RE: ITB No. 21-117 Murphey Candler Park – Pool Parking Improvements

Please see Addendum No. 1 for the above-referenced solicitation.

ADDENDUM NO. 1
Invitation to Bid, No. 21-117
Murphey Candler Park – Pool Parking Improvements
Attachments
REVISED 10/12/2021

1
NEW ASPHALT PAVING — TYP.
1-1/2"=1'-0" REPLACE DETAIL 4/C8.6A

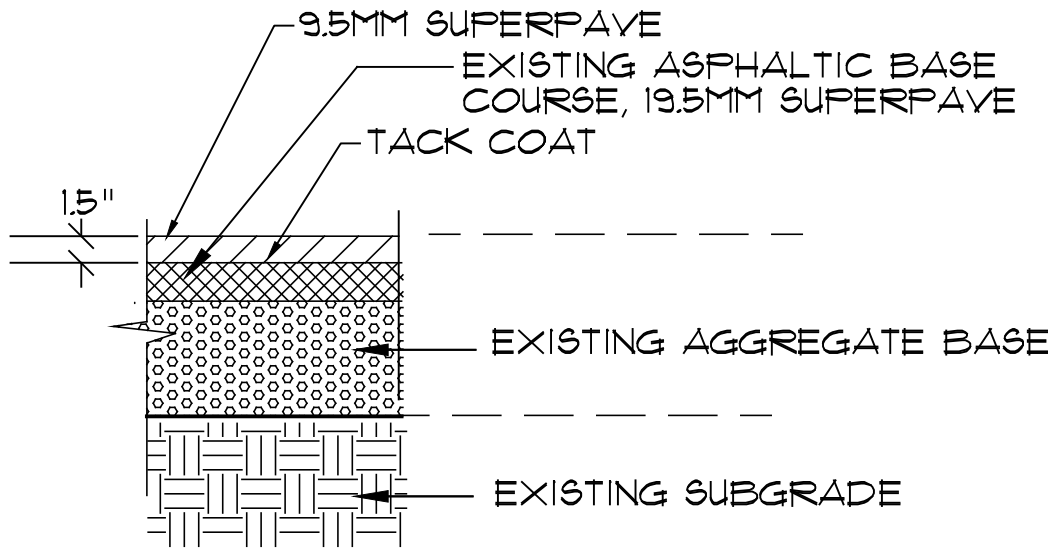
NOTE: ASPHALTIC CONCRETE PAVING TO MEET GEORGIA DEPARTMENT OF TRANSPORTATION STANDARDS. SURFACE COURSE NOT TO BE PAVED UNTIL ALL HEAVY CONSTRUCTION (AND RELATED TRAFFIC) IS COMPLETE.

2 ASPHALT PAVING OVERLAY, TYP.
 1-1/2"=1'-0" REPLACE DETAIL 5/C8.6A

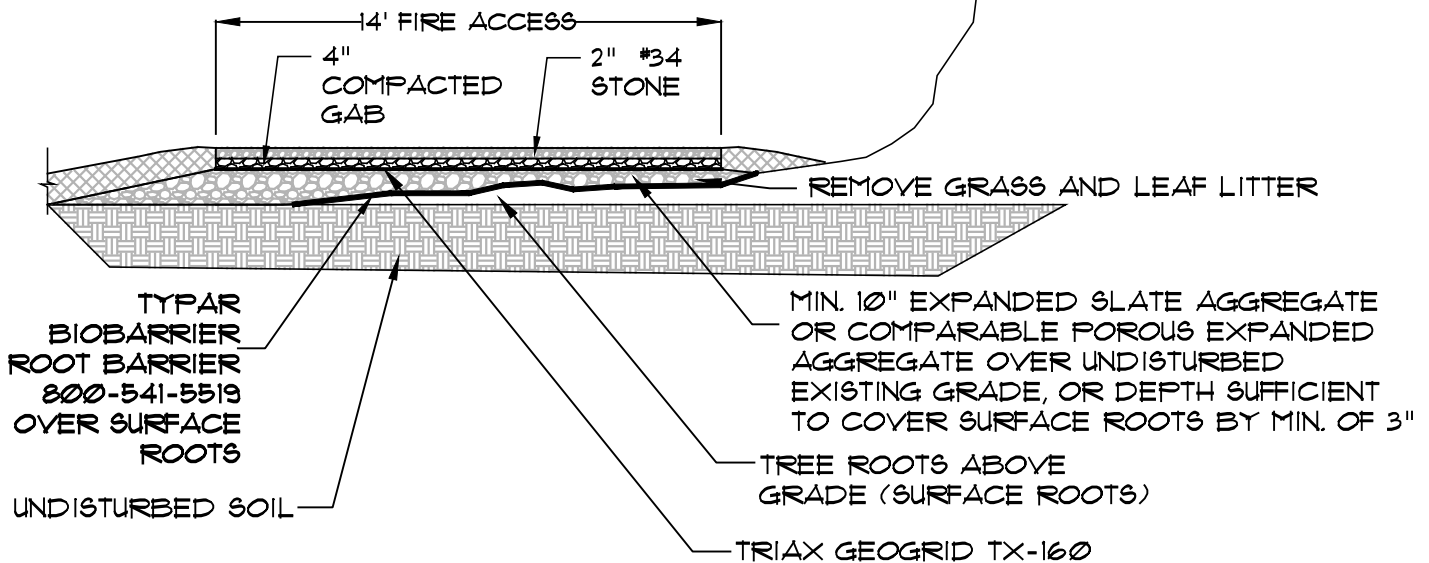
NOTE: OVERLAY ASPHALT MILL OF 1.5 IN TO BE CONDUCTED PRIOR TO PATCHING AND OVERLAY.

REPLACE DETAIL 1B/C8.6B

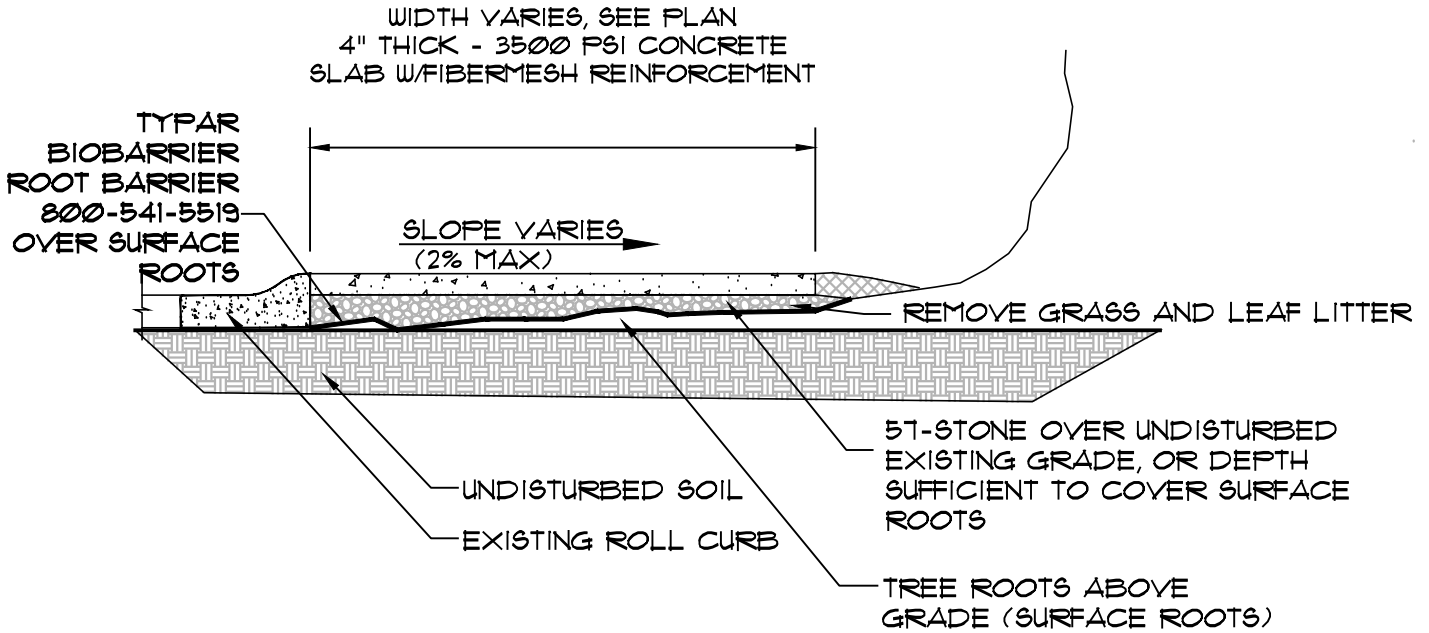
WHERE FIRE ACCESS ROAD PASSES CLOSE TO A TREE, CONTRACTOR SHALL "FLOAT" THE ACCESS ROAD ABOVE THE LEVEL OF EXISTING GRADE IN ORDER TO AVOID DAMAGE TO THE ROOTS. CONTRACTOR SHALL COORDINATE SUCH SPECIAL CONSTRUCTION IN THE FIELD WITH THE LANDSCAPE ARCHITECT OR OWNER REPRESENTATIVE. GAB SHALL BE "WALKED IN" TO TOP LAYER OF TOPSOIL WITH LIGHTWEIGHT EQUIPMENT.

CONCRETE TRAIL OVER TREE ROOTS
NTS
REPLACE DETAIL 4/C8.6B

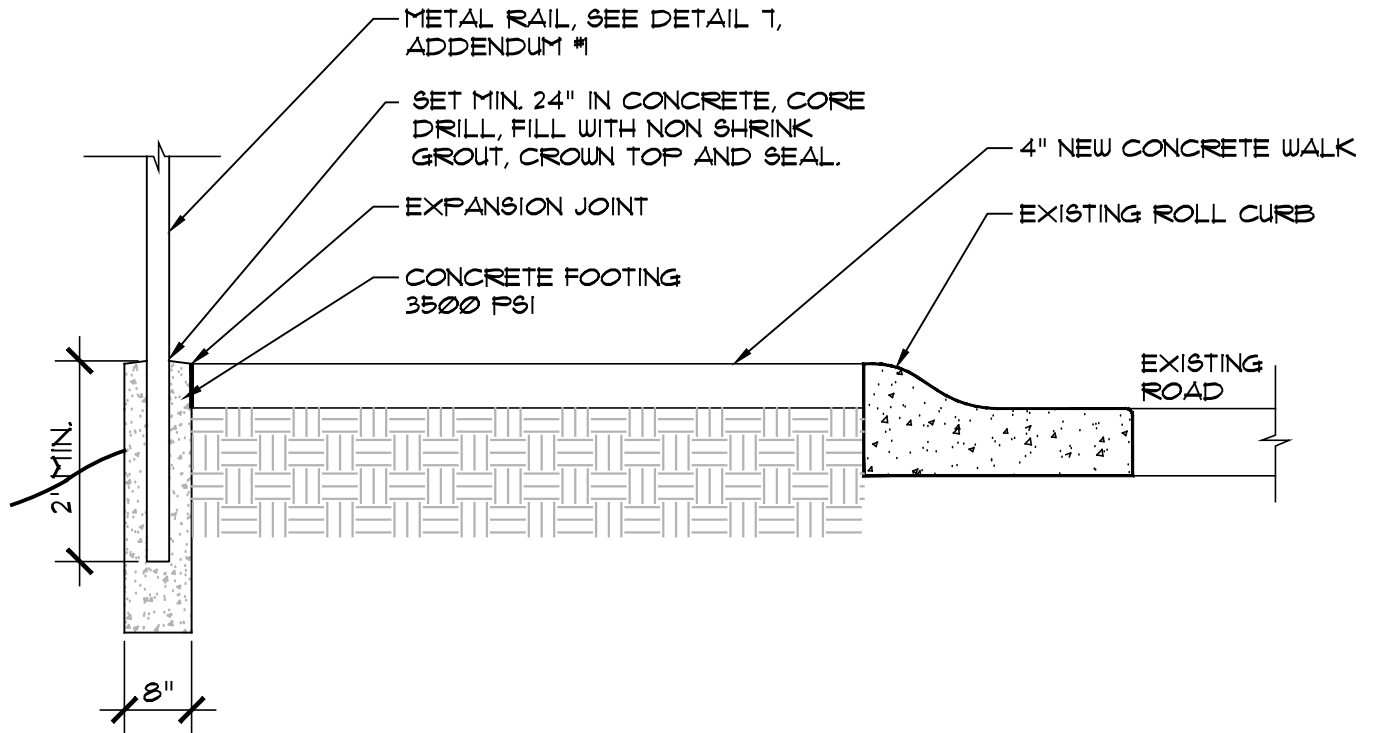
WHERE SIDEWALK PASSES CLOSE TO A TREE, CONTRACTOR SHALL "FLOAT" THE SIDEWALK ABOVE THE LEVEL OF EXISTING GRADE IN ORDER TO AVOID DAMAGE TO THE ROOTS. CONTRACTOR SHALL COORDINATE SUCH SPECIAL CONSTRUCTION IN THE FIELD WITH THE LANDSCAPE ARCHITECT OR OWNER REPRESENTATIVE.
